Access Compliance Report

Public Rights-of-Way

Intersection ID: 31891	Main Street: CENTERLINE_DR	Cross Street: MOUNTAIN_SPRINGS_DR	Location: E
ADA ID: C50AE7D00227	Ramp Type: PerpDiag	Initial Pass/Fail: Fail	Overall Compliance: No
		Severity Score: 10

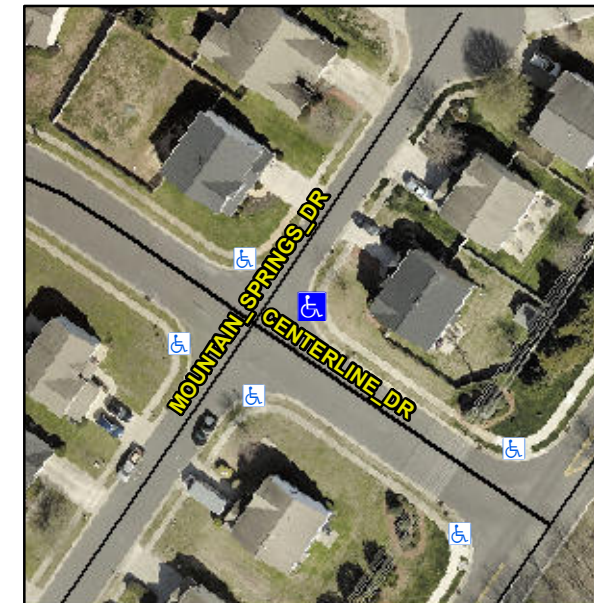
Not Found, R304.5.1, R304.5.3

Compliance	Description	Data	Compliance	Description	Data
N/A	Ramp Length (in)	46.0	Yes	Ramp Slope (%)	6.7
No	Ramp Width (in)	39.0	No	Ramp XSlope (%)	2.1
N/A	Flare Type LT	N/A	N/A	Flare Type RT	N/A
N/A	Flare Slope LT (%)	N/A	N/A	Flare Slope RT (%)	N/A
N/A	Flare Traversable LT?	N/A	N/A	Flare Traversable RT?	N/A
N/A	Landing Length (in)	N/A	N/A	DWS Provided?	N/A
N/A	Landing Width (in)	N/A	N/A	DWS Contrast?	N/A
N/A	Landing Slope (%)	N/A	N/A	DWS Length (in)	N/A
N/A	Landing X Slope (%)	N/A	N/A	DWS Full Width?	N/A
N/A	Landing Curb? (Y/N)	N/A	N/A	DWS Offset (in)	N/A
N/A	Shared Landing?	N/A			
N/A	Gutter Ponding?	N/A	N/A	Gutter Slope (%)	N/A
N/A	Gutter Lip Ht (in)	N/A	N/A	Gutter X Slope (%)	N/A
N/A	Painted X Walk1?	No	N/A	Painted X Walk2?	No
	X Walk 1 Direction	To NW		X Walk 2 Direction	To SW
N/A	X Walk 1 Width (in)	N/A	N/A	X Walk 2 Width (in)	N/A
	X Walk 1 Slope (%)	1.6		X Walk 2 Slope (%)	1.3
	X Walk 1 X Slope (%)	0.3		X Walk 2 X Slope (%)	3.2

Remove & Replace Curb Ramp With Two New Directional Ramps or Equivalent.
